Waste Control Specialists LLC's Consolidated Interim Spent Fuel Storage Facility Project

Interim Storage Partners Consolidated Interim Storage Facility Project

Comments on CIS DEIS
By
Marvin Resnikoff, Ph.D.¹
Radioactive Waste Management Associates
September 2020

Figure 1. Rail Fires, Yrs 2000 – 2009.

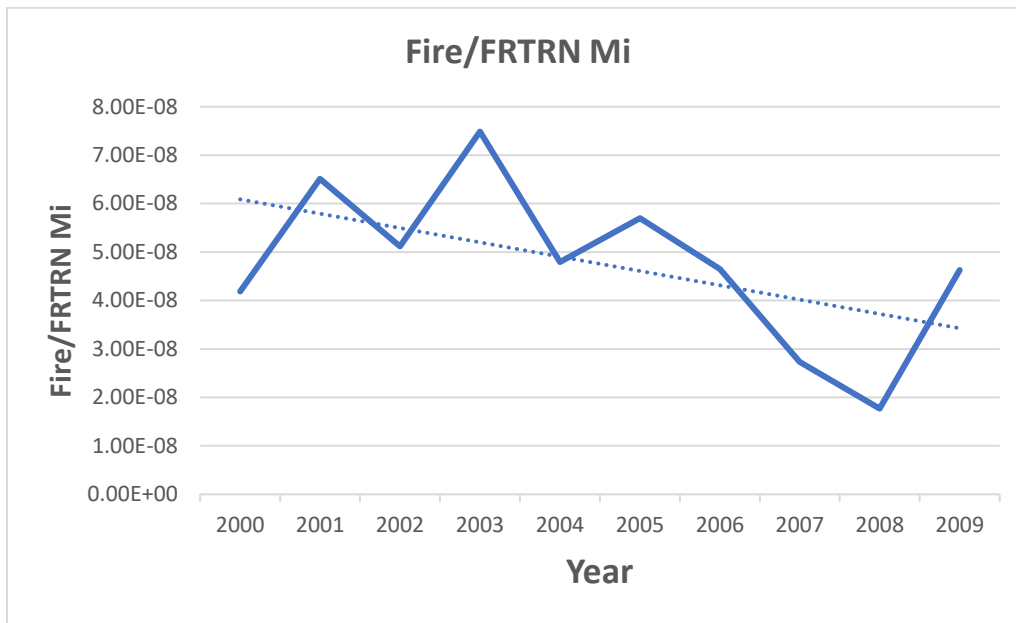
While the rail accident rate, according to FRA, has declined in the years between 2010 and 2018, the same is not true for the fire accident rate, which has risen over the same years. Our review of the FRA data show 392 accidents involving fire of varying severity between the years 2010 through 2018, ranging between 16 and 79 fire accidents per year. Comparing the periods 2000 to 2009 considered in NUREG-2125, and the period 2010 to 2018, the fire accident rate has almost doubled. NRC staff should consider the most recent data. Graphs showing rail fires per freight train mile for the years 2000 – 2009, and years 2010 – 2018 appear as Fig. 1 and 2, respectively. The reason for this increase of fire accidents is not difficult to understand; more tanker cars are on the rail, mainly from North Dakota to refineries on both coasts.

The bottom line is more fires have been occurring per accident than is acknowledged by NUREG-2125.
